TOWN OF YORKTOWN PLANNING DEPARTMENT

To: Planning Board
From: Planning Department
Date: July 8, 2021
Subject: 3666 Old Yorktown Road
Request for Fence
SBL: 16.11-1-60

To: Town Board
From: Planning Department
Date: August 3, 2021
Subject: 1789 Baldwin Road
Section 37.17, Block 1, Lot 54

SITE PLAN
AND
SWPPP
PREPARED FOR
GIOVANBATTISTA &
LAUREN APOLLONIO
LOCATED AT
1789 BALDWIN ROAD
TOWN OF YORKTOWN
WESTCHESTER CO., NY
JULY 1, 2021
SHEET 1 OF 2 SHEETS

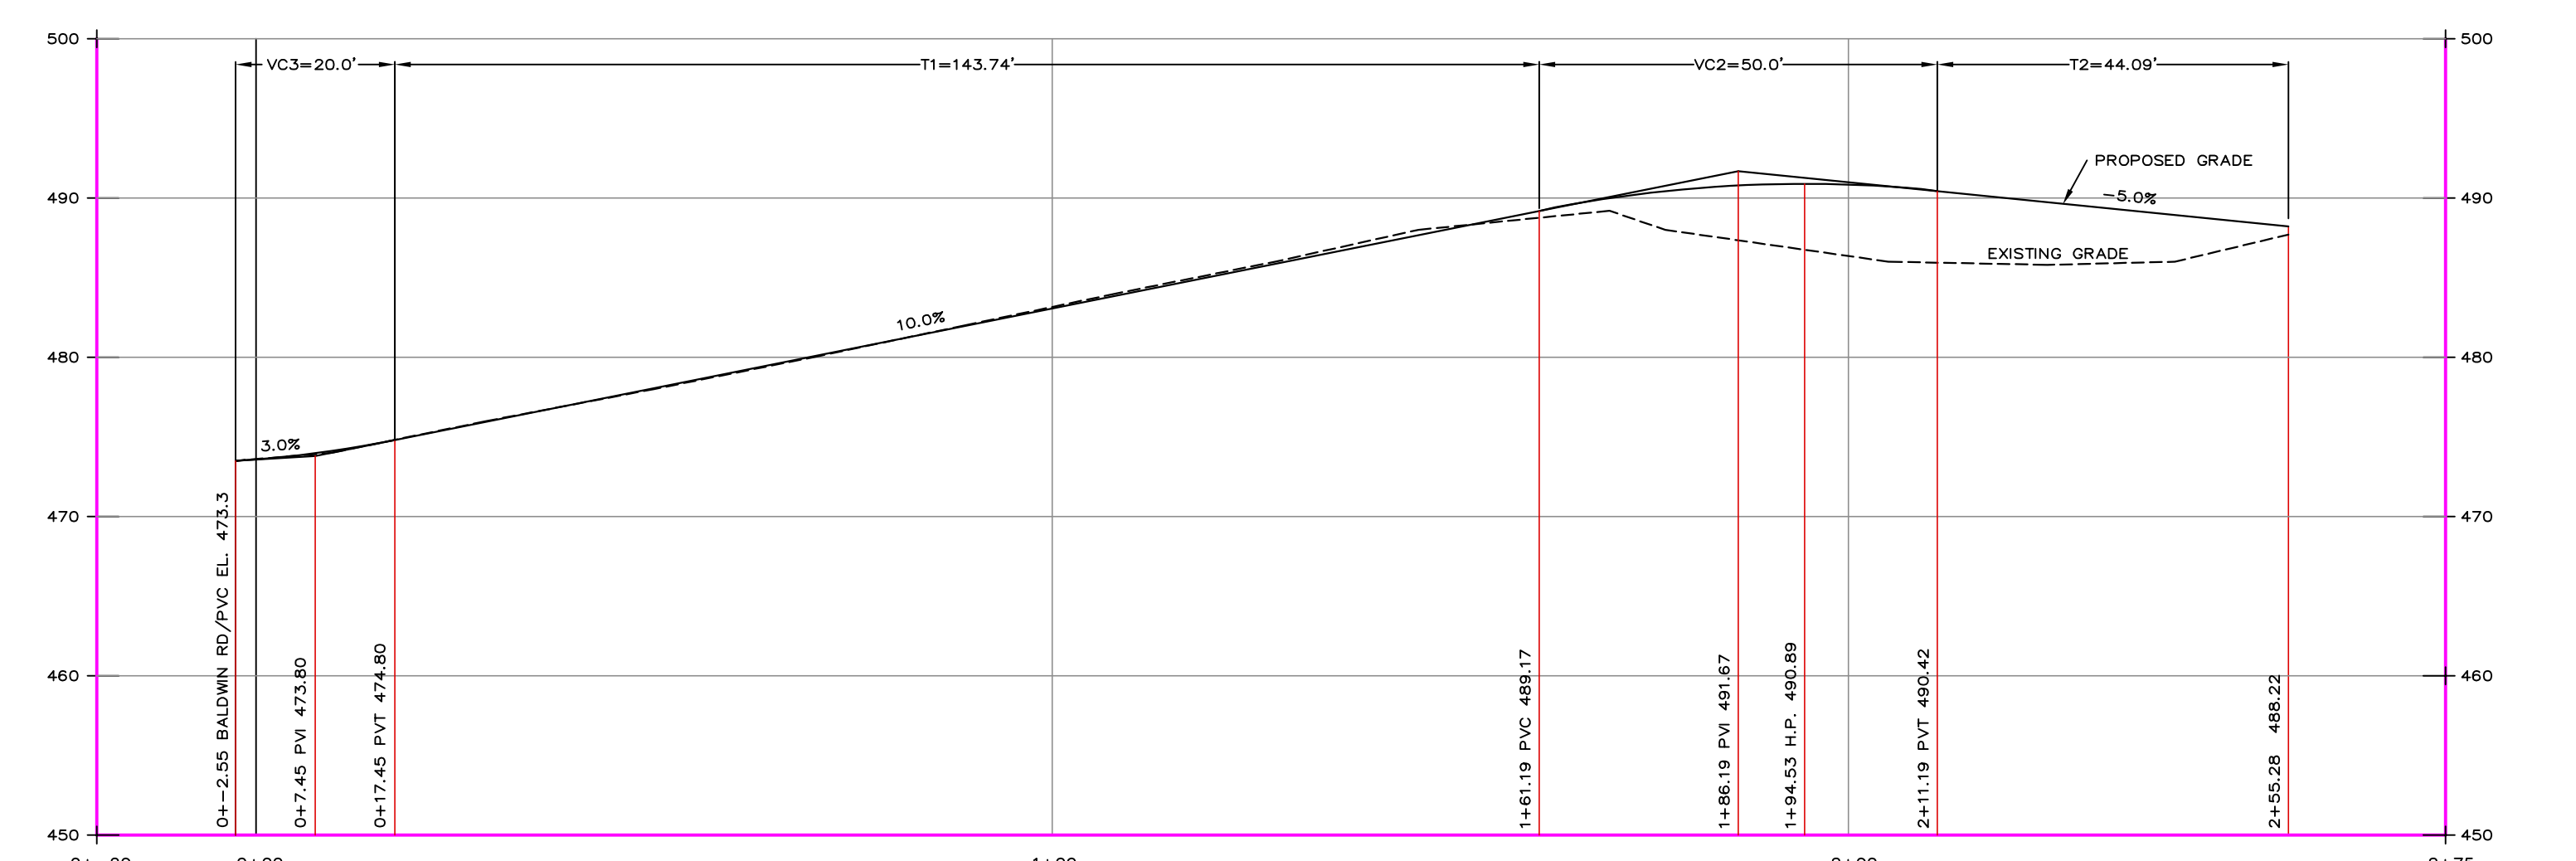
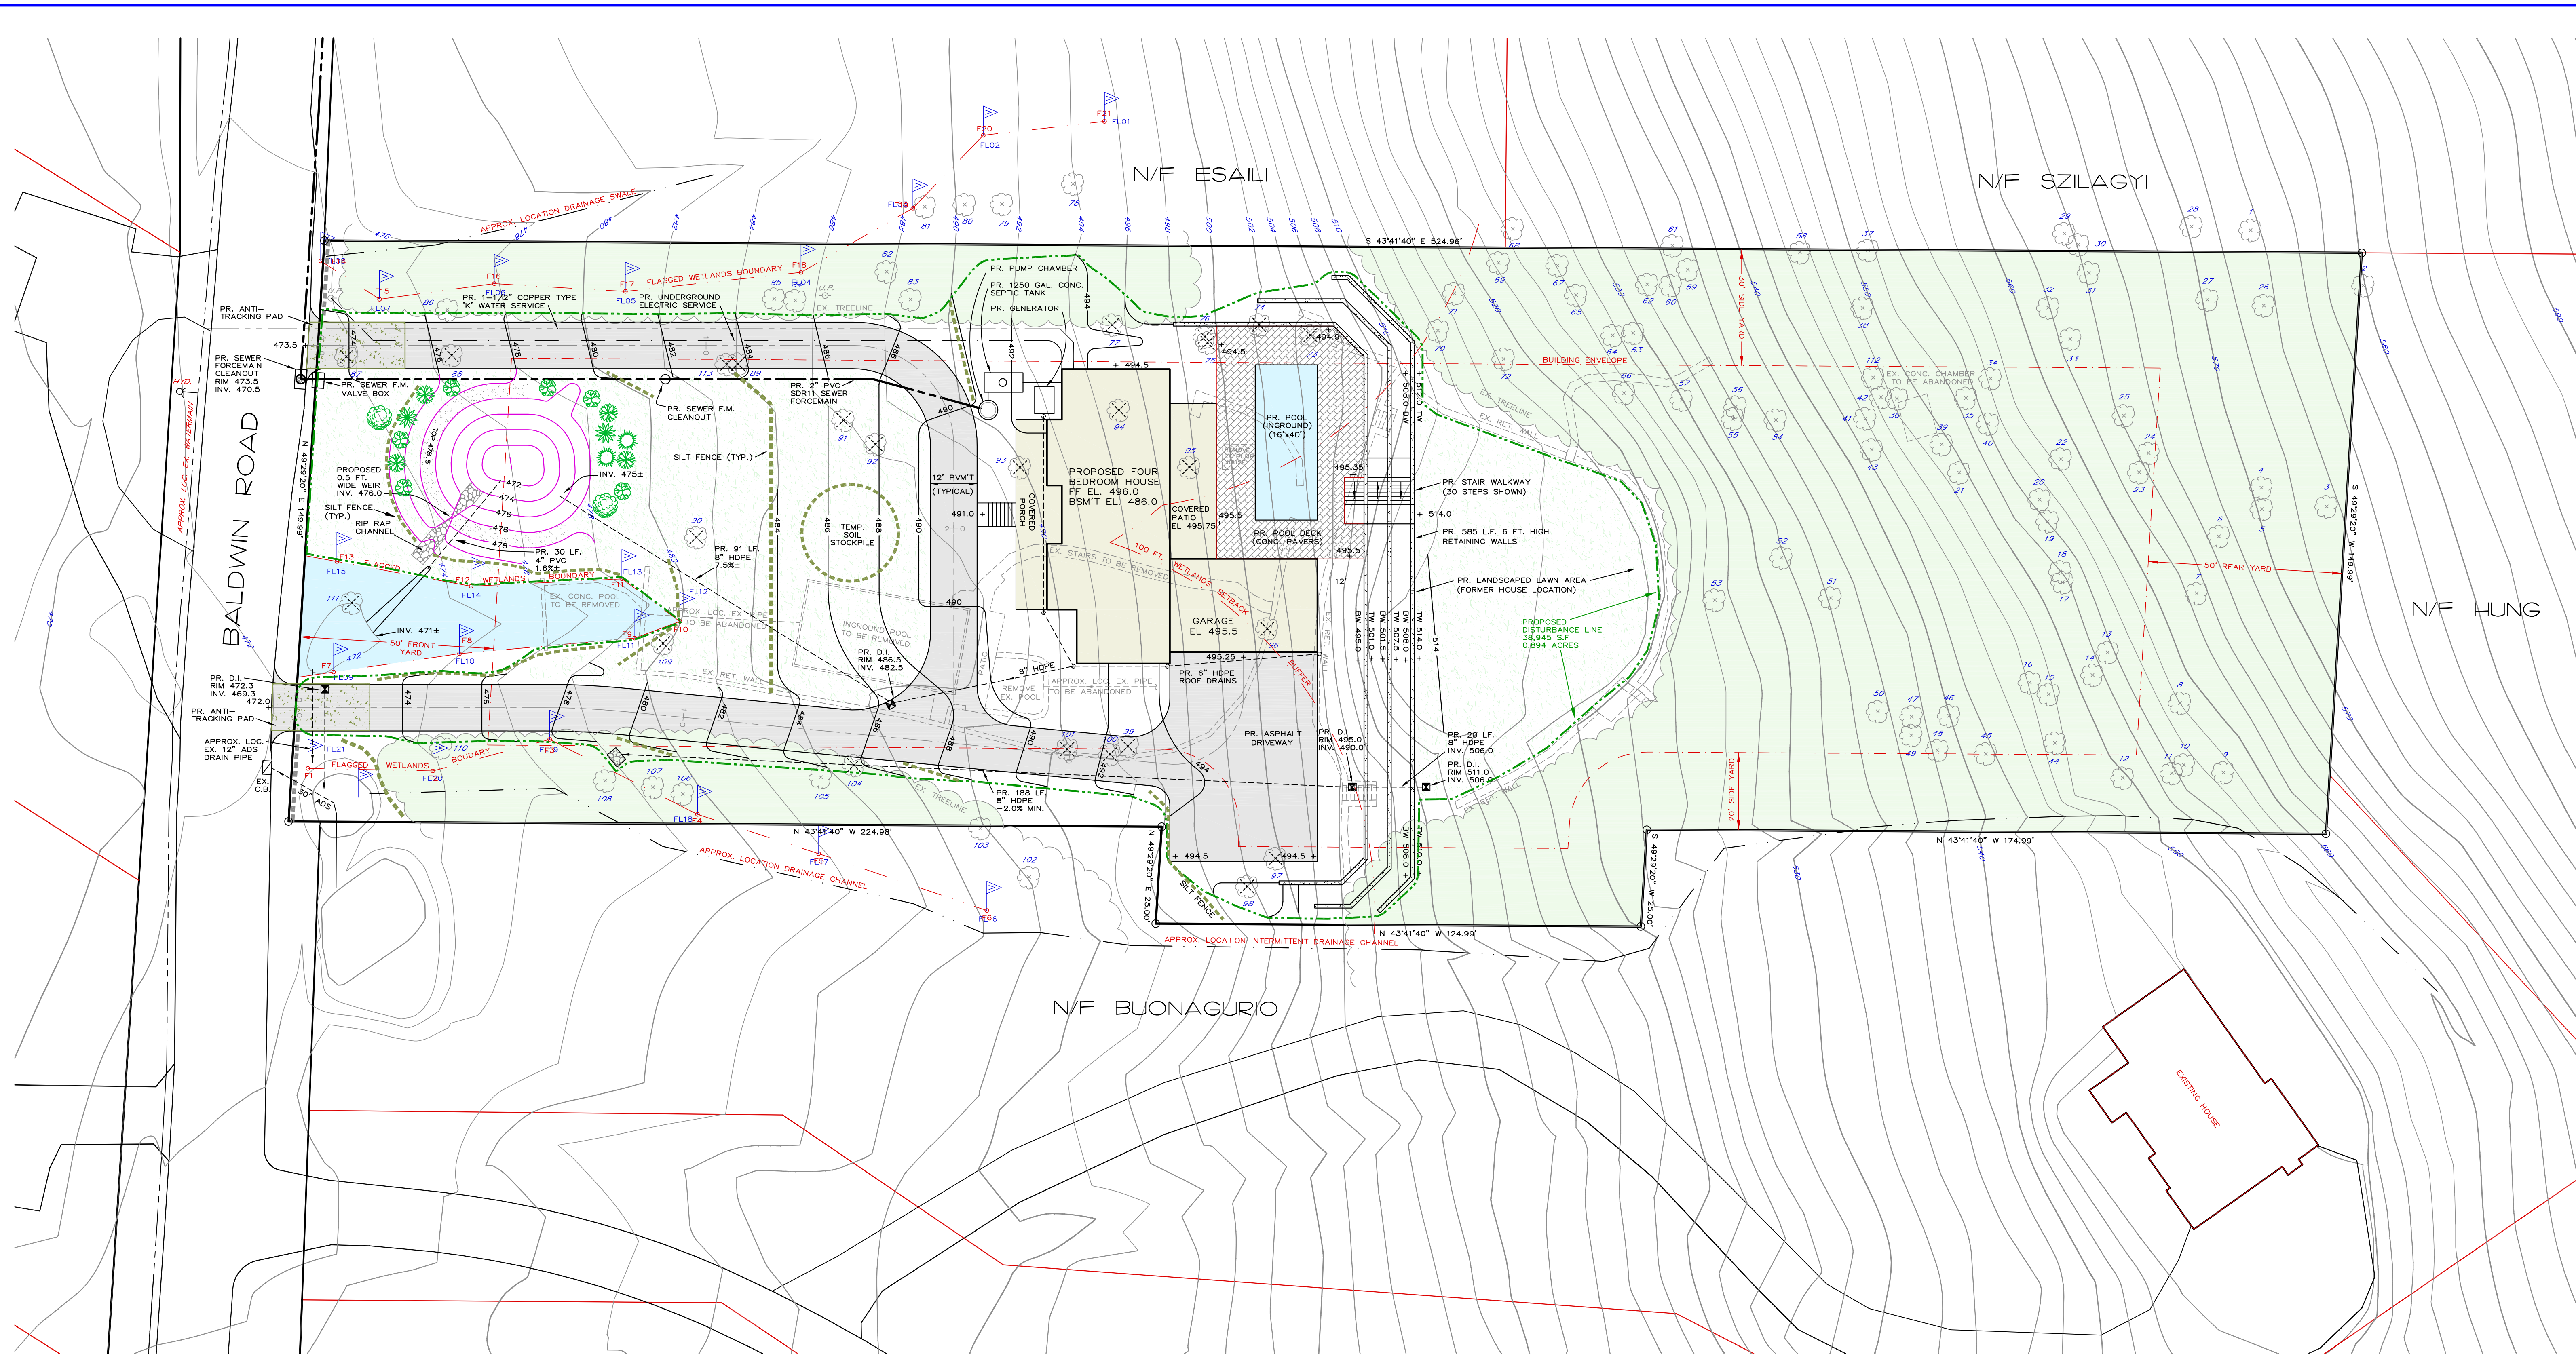
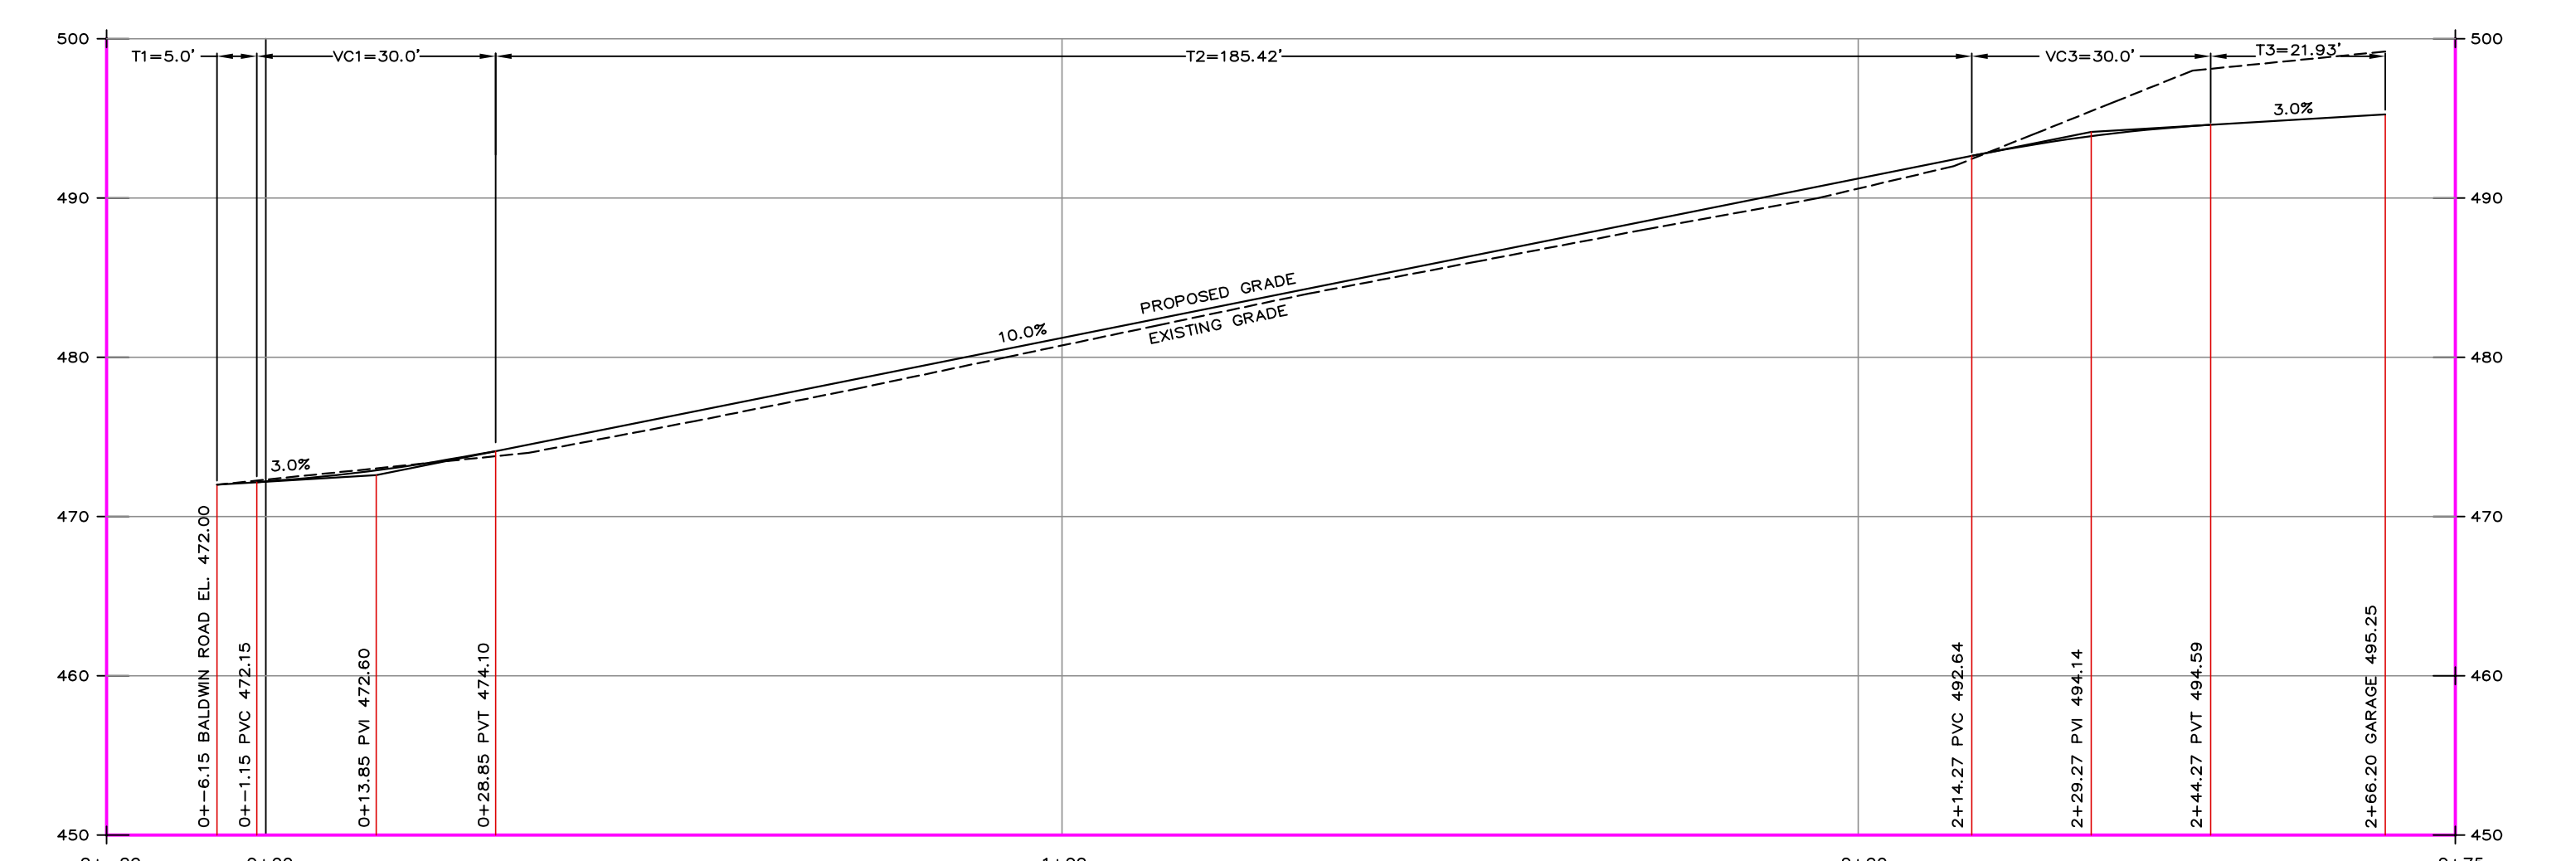
1. The maps and site plans indicate the presence of wetlands on the site, and the associated buffer areas appear to constrain the majority of the site. We could not identify any mitigation for the proposed disturbance to the wetland buffer area on the site plans.

3. The site plan shows approximately 24 trees are proposed to be removed, however, we found no proposed tree mitigation measures.
4. An existing conditions plan or survey should be submitted to clarify the project parameters and scope.

The Planning Department recommends the applicant provide the information above for review.
